**Record filed by
The City of Charlottetown
In the matter of
Sheila Scott v. City of Charlottetown
(Appeal #LA23001)**

Submitted by Melanie McKenna
on behalf of the City of Charlottetown

September 14, 2026

A-7

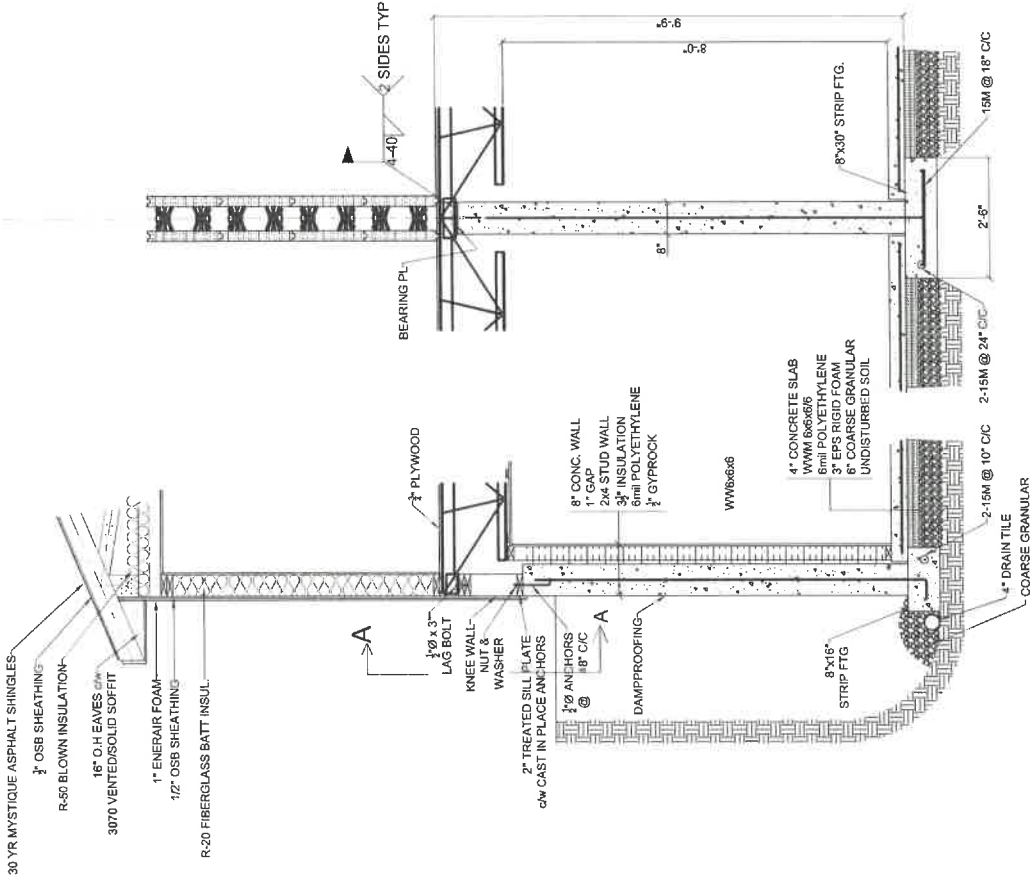
5. Provide a typical exterior wall cross-section showing the basement walls that includes construction details such as: insulation, vapour barrier, dampproofing, drain tile, etc. **– See A-7 "Krish Semi Final"**

MARK: T04B
QTY: 2
DATE: 2021-06-28

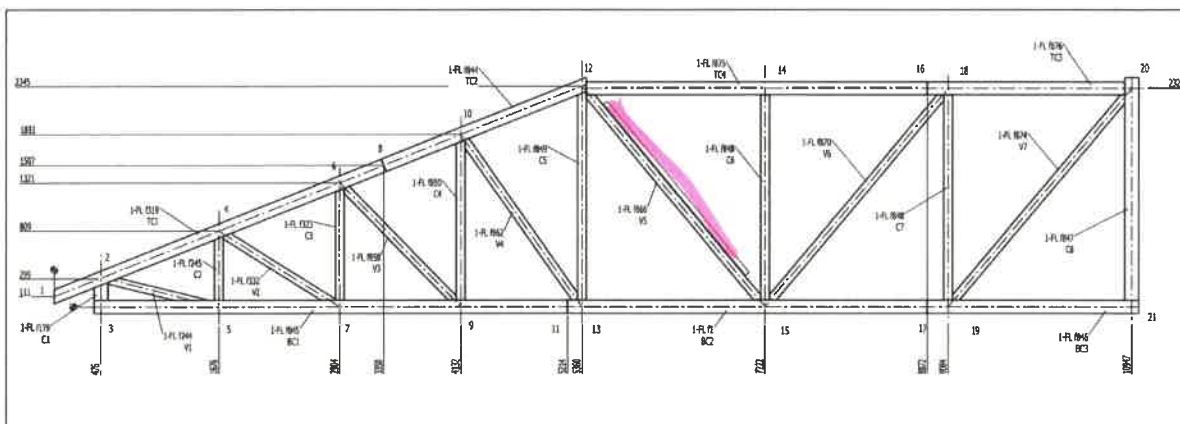
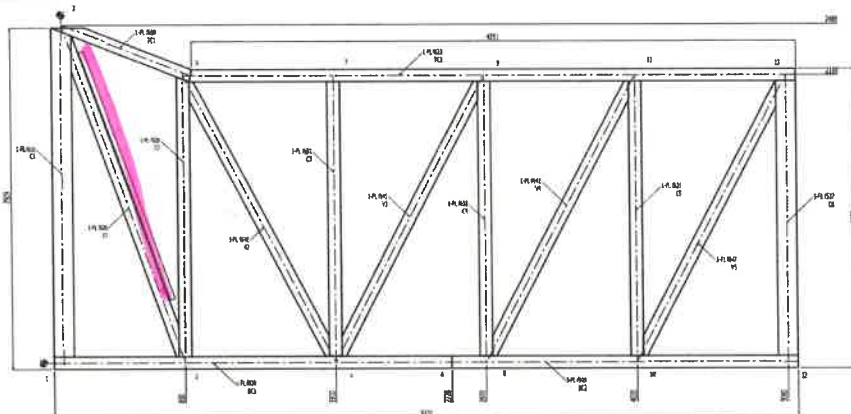
1. I don't appear to have Truss T01C drawing. Please submit for review. **See Shop Dwgs for Trusses**
2. I happened to notice that Truss T04B drawing shows negative loads for reactions at both ends. Please revise and resubmit if changes are required. **Corrected**
